Carolina Power & Light Company

FILE: NG-3514(B)

SERIAL: GD-79-2050

BRUNSWICK STEAM ELECTRIC PLANT, UNIT NOS. 1 AND 2
DOCKET NOS. 50-325 AND 50-324
LICENSE NOS. DPR-71 AND DPR-62
REQUEST FOR LICENSE AMENDMENT - CORPORATE ORGANIZATIONAL CHANGES

MANAGEMENT ORGANIZATION CHART
FIGURE 6.2.1-1(Prime)

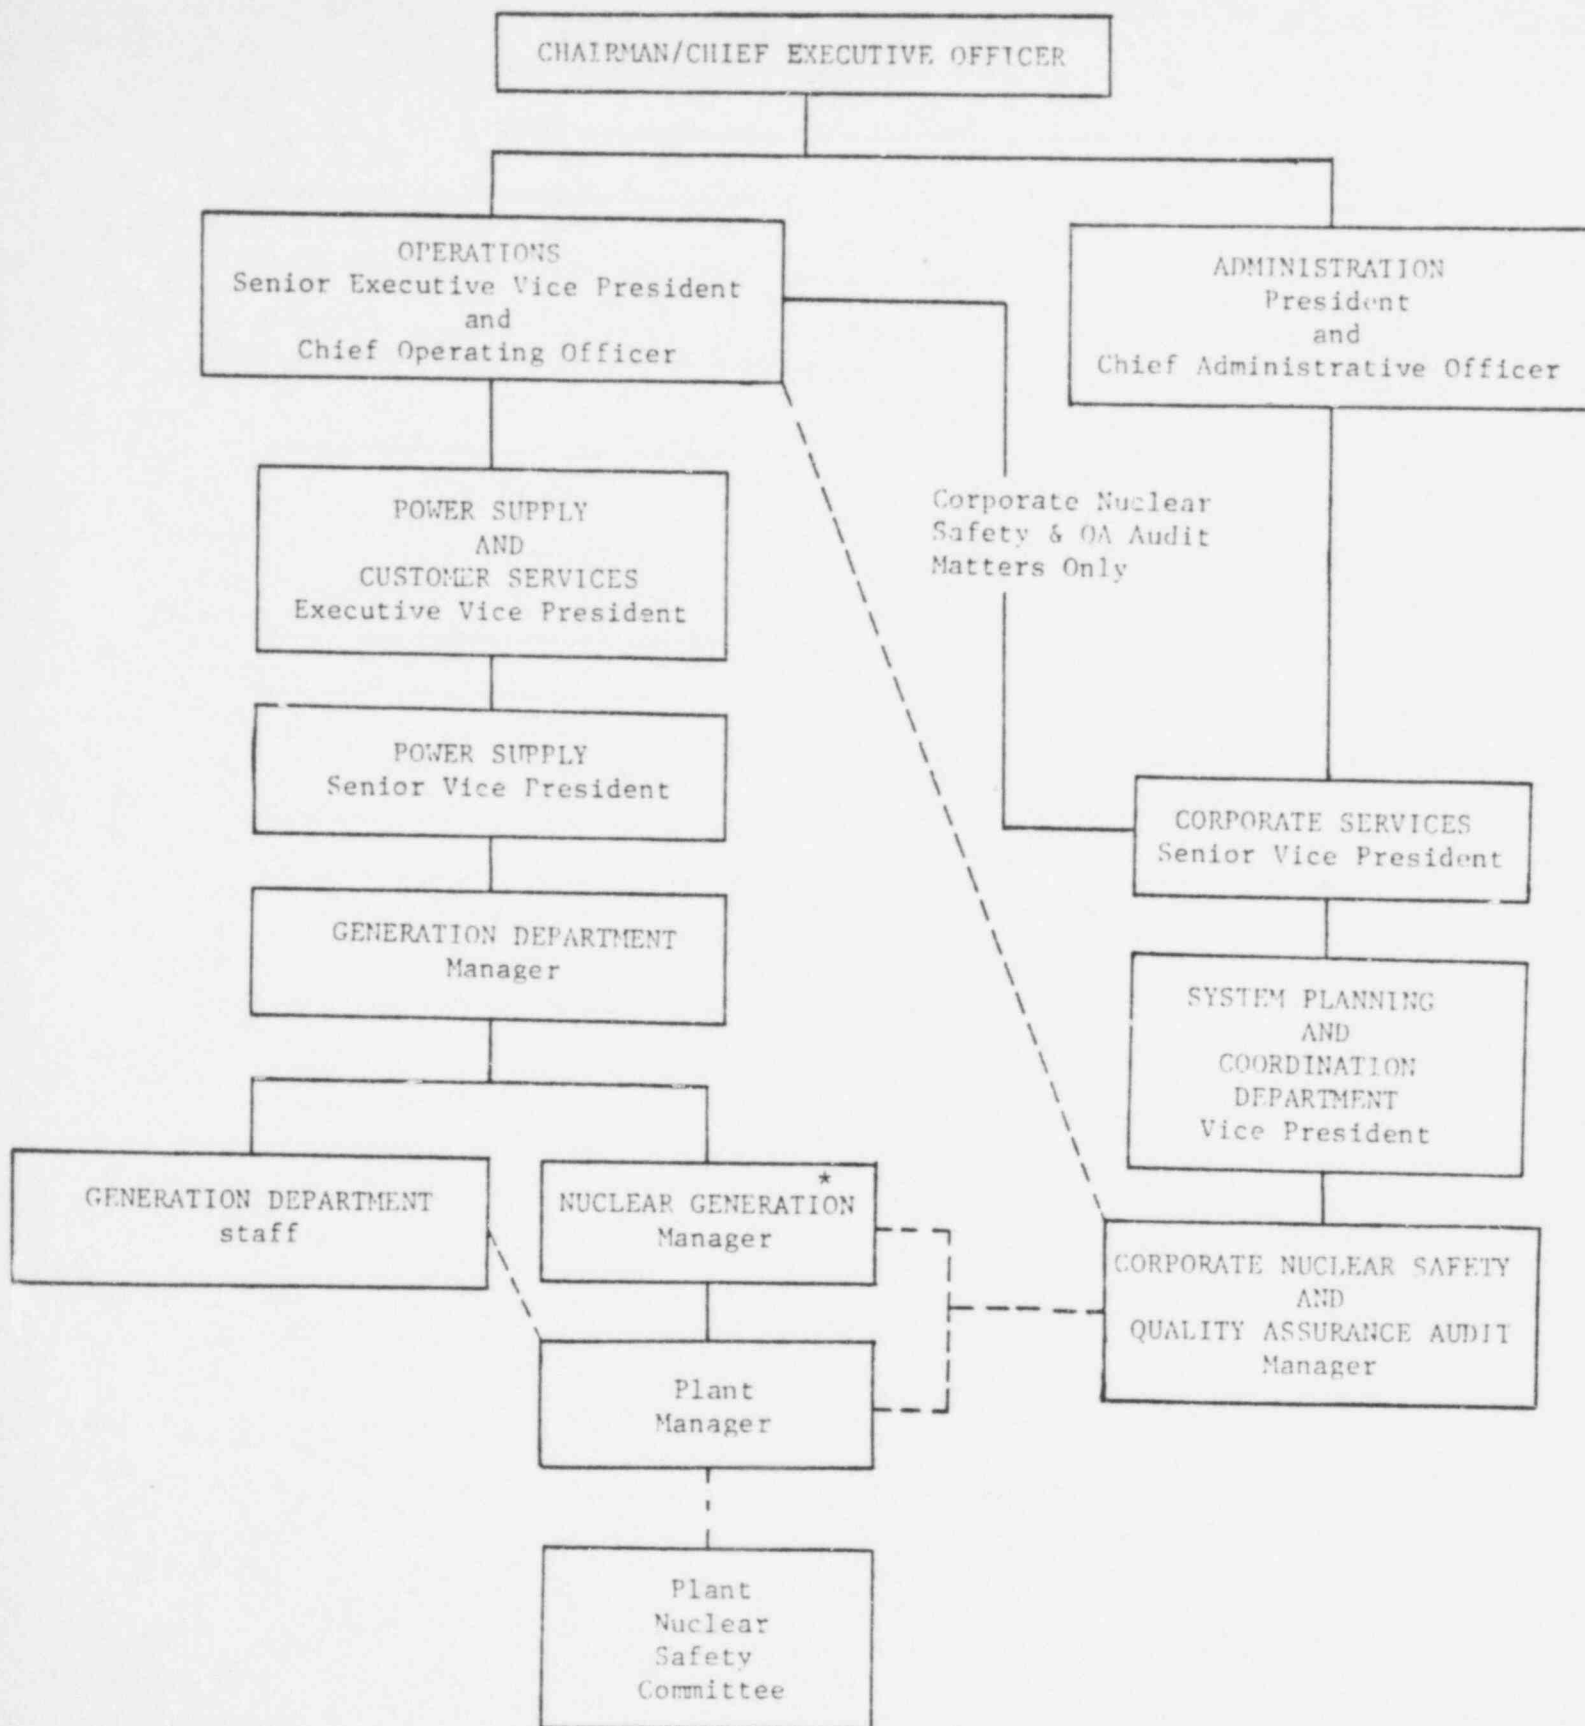
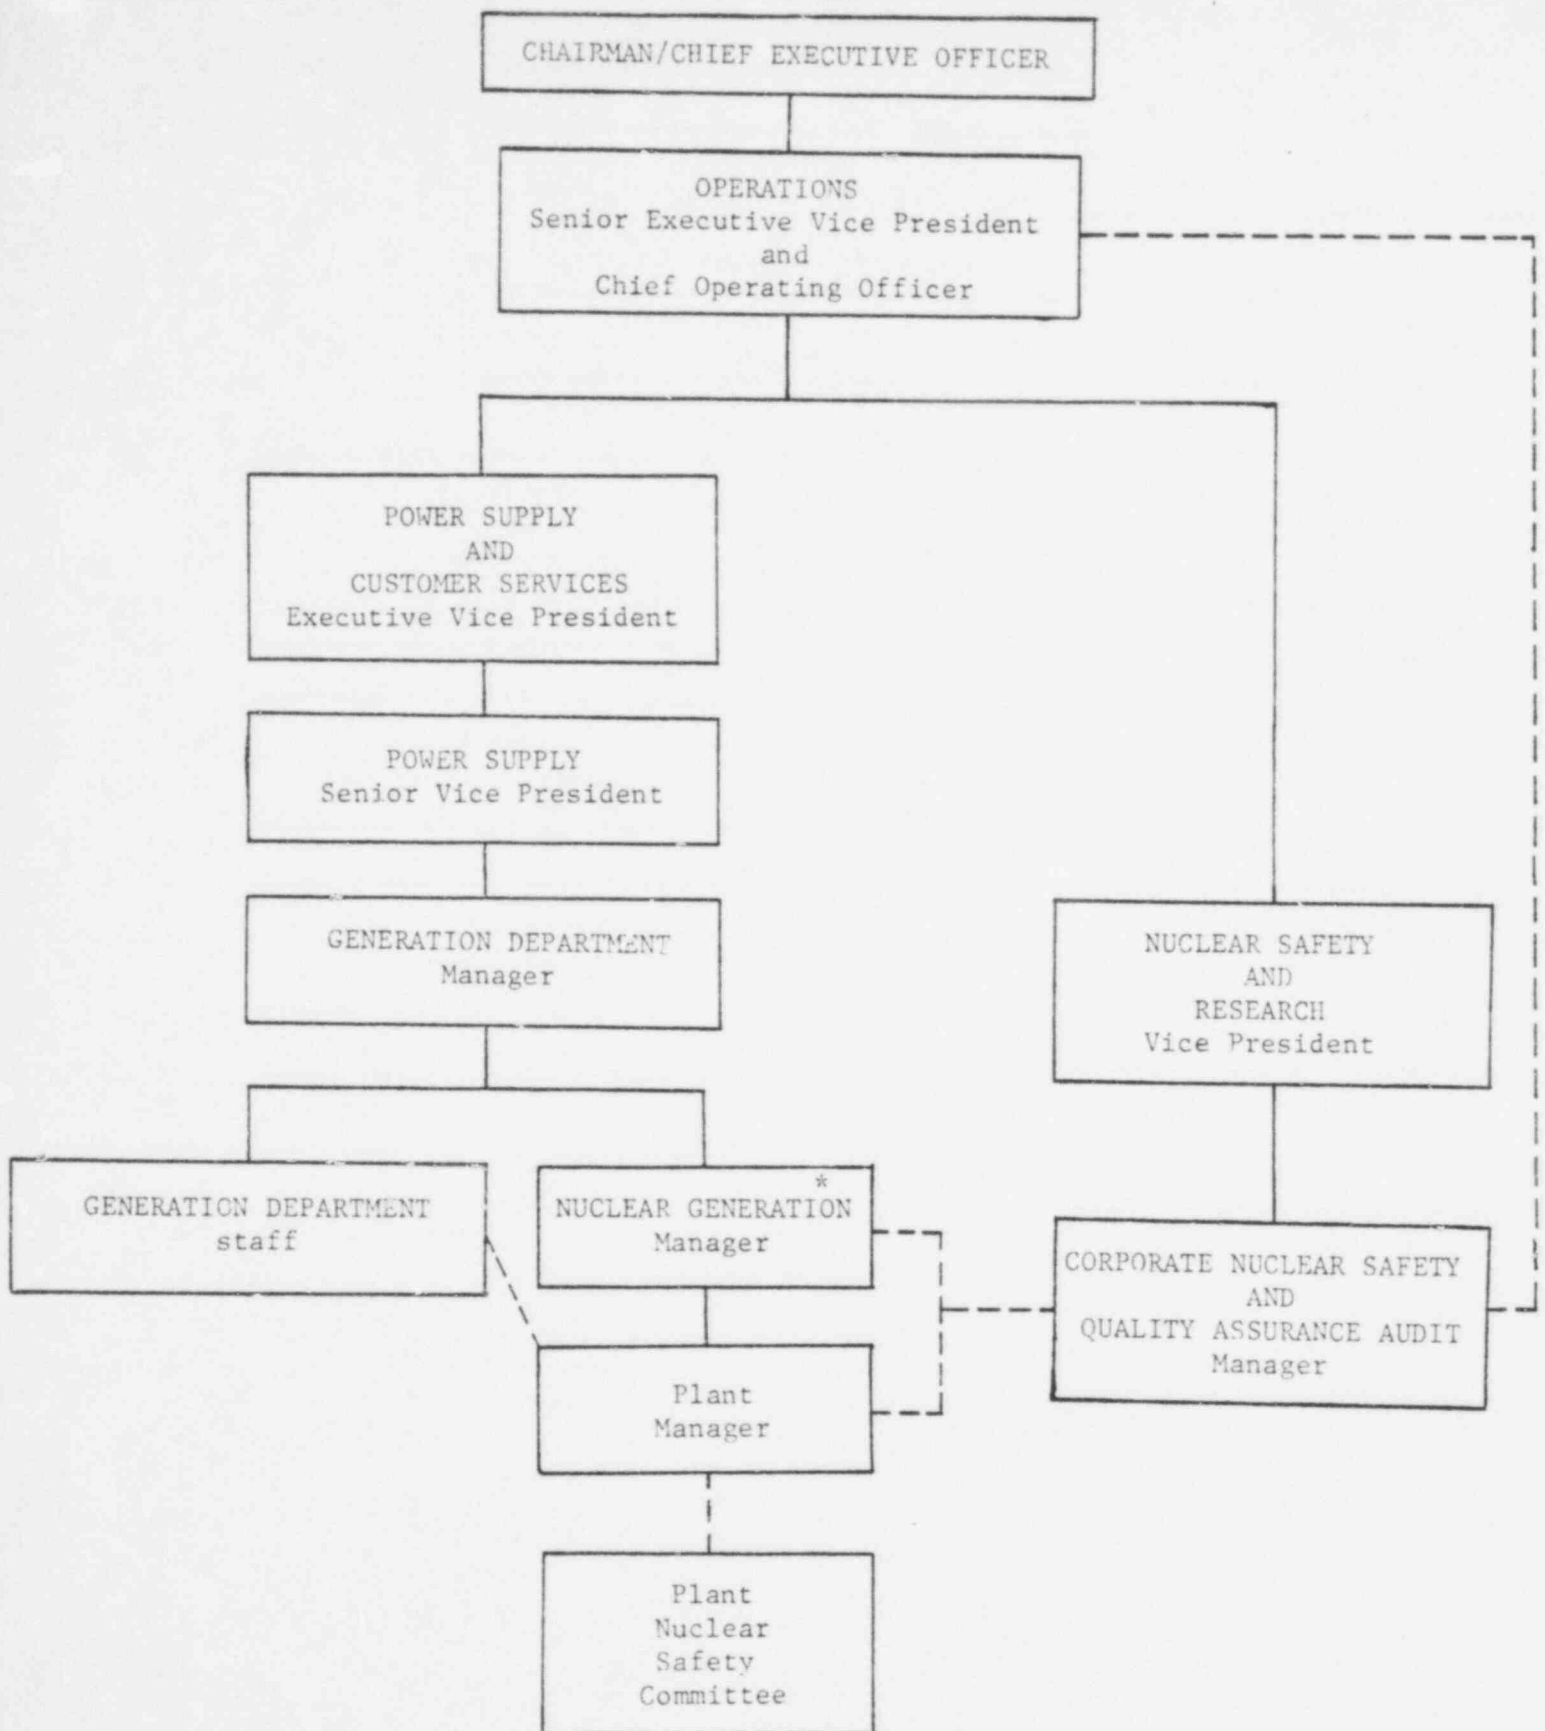
As before, Mr. J. A. Jones remains as the Chief Operating Officer for CP&L and is the addressee for official correspondence from the NRC. His title, however, is now Senior Executive Vice President. I am now Executive Vice President - Power Supply & Customer Services. My former position, Senior Vice President - Power Supply, is now held by Mr. D. V. Menscer.

Effective September 1, 1979, there will be a new Department of Nuclear Safety and Research, headed by Dr. T. S. Elleman. This new department will include the functions of Research, Health Physics, and Corporate Nuclear Safety and Quality Assurance Audit.

6.2.1 The offsite organization for facility management and technical support shall be as shown on Figure 6.2.1-1 (Prime).

Figure 6.2.2-1

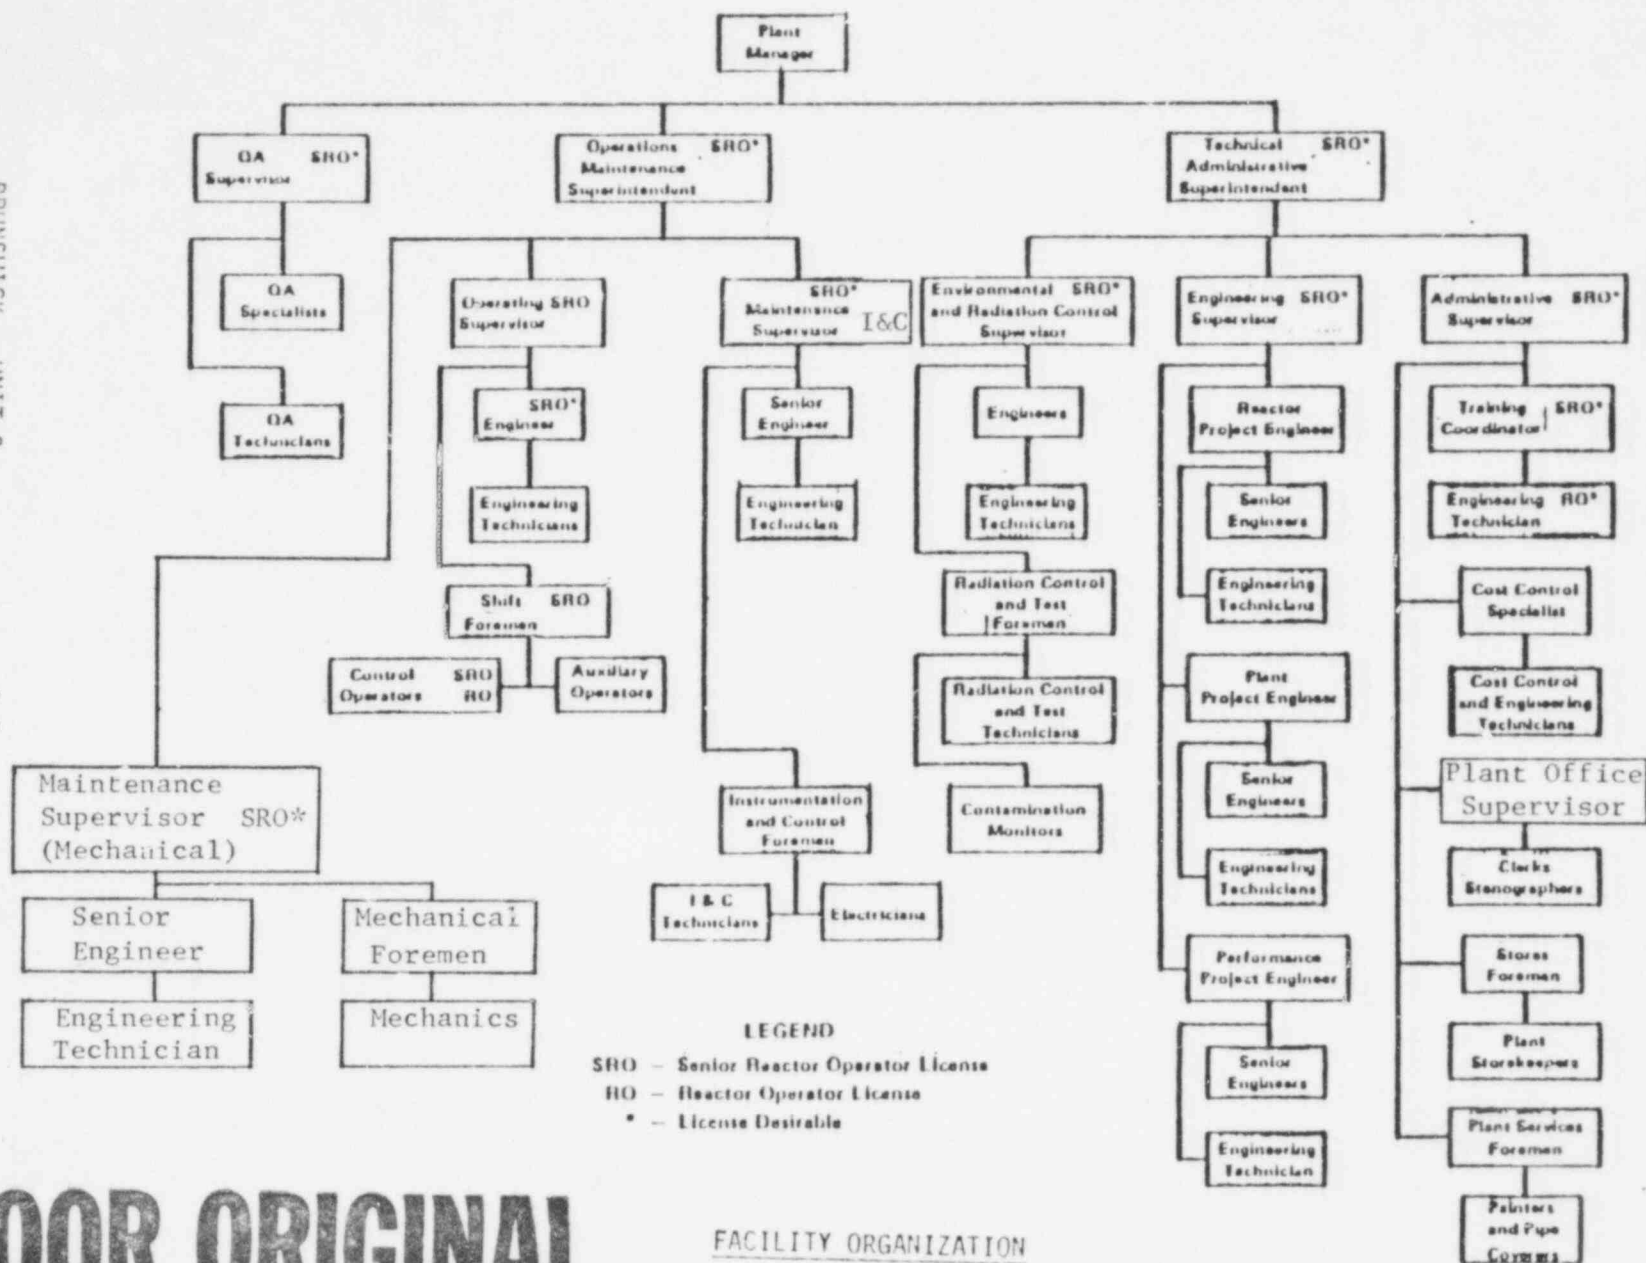
Enclosed are the revised pages for the Brunswick Units 1 and 2 technical specifications which reflect these revisions. Changes are indicated by vertical lines in the right-hand margins of the affected pages. Some pages will only be effective through August 31, 1979 and are denoted by (Prime) printed after the page number. Some pages are not to become effective until September 1, 1979 and are so noted. The remaining pages show neither of these notations and should become effective as soon as possible.
